Well Name: NOW I WON 25-24
FEDERAL COM

Sundry ID: 2835692

Type of Action: APD Change

Procedure Description: OXY USA INC., respectfully requests to amend the subject AAPD by revising the Well Name, SHL, BHL, HSU, TVD, Drill Plan & Well Pad as follows: Old Well Name: NOW I WON 25_24 FEDERAL COM 3H New Well Name: OLIVE WON UNIT 103H Old SHL: 490' FSL 2526' FEL New SHL: 442' FSL 1148' FEL Old BHL: 20' FNL 1785' FEL New BHL: 20' FNL 2590' FEL Old HSU: 320 acres New HSU: 640 acres Old Well Pad: 25_3 New Well Pad 25_2 Old TVD: 9752' New TVD: 9887' Attached is the updated C102, Drill Plan, Blanket Pad Design, Directional Survey & APD Change Sundry Worksheet

C-102 Submit Electronically Via OCD Permitting	State of New Mexico Energy, Minerals, & Natural Resources Department OIL CONSERVATION DIVISION	Revised July 9, 2024 PAGE 1 OF 2
		Submittal Type: ☐ Initial Submittal ☒ Amended Report ☐ As Drilled

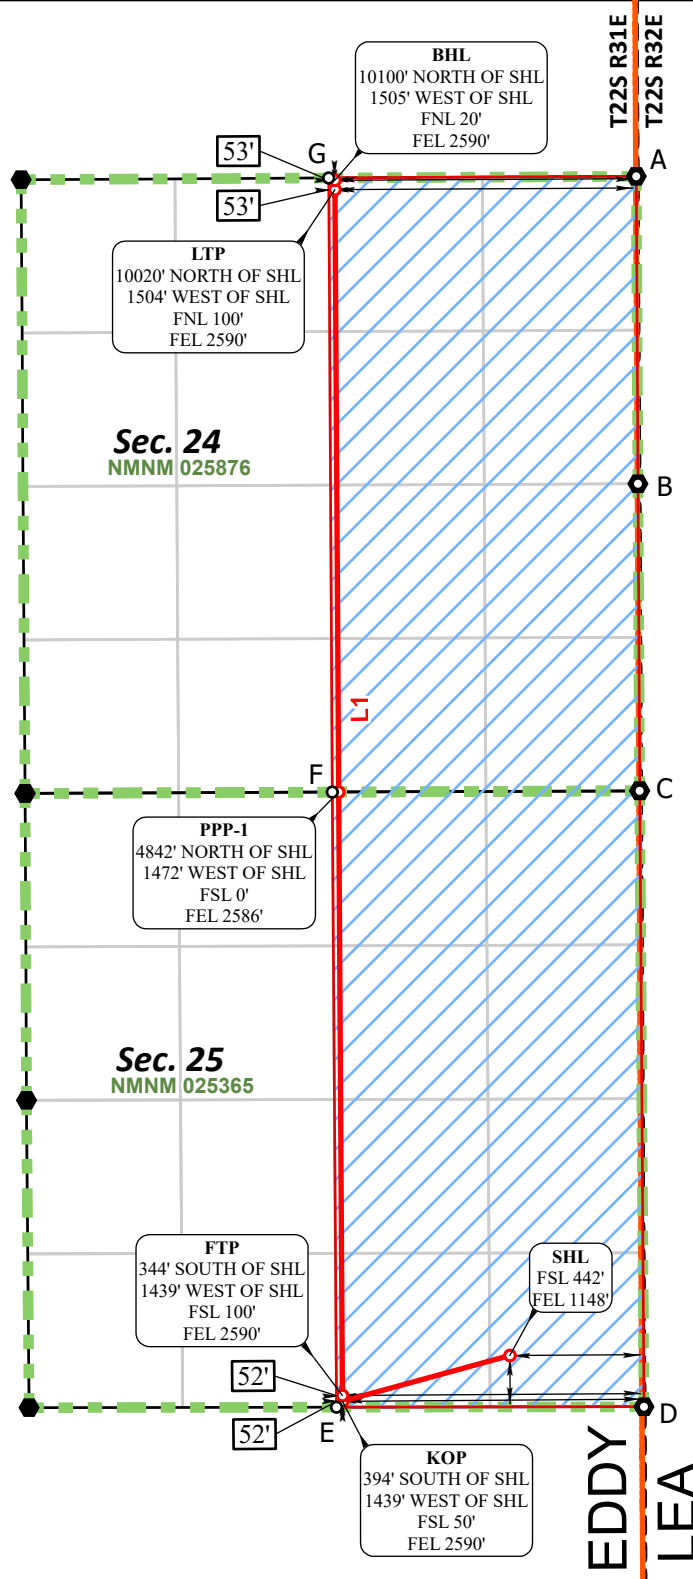
Old SHL: 490' FSL 2526' FEL
New SHL: 442' FSL 1148' FEL

Old BHL: 20' FNL 1785' FEL
New BHL: 20' FNL 2590' FEL
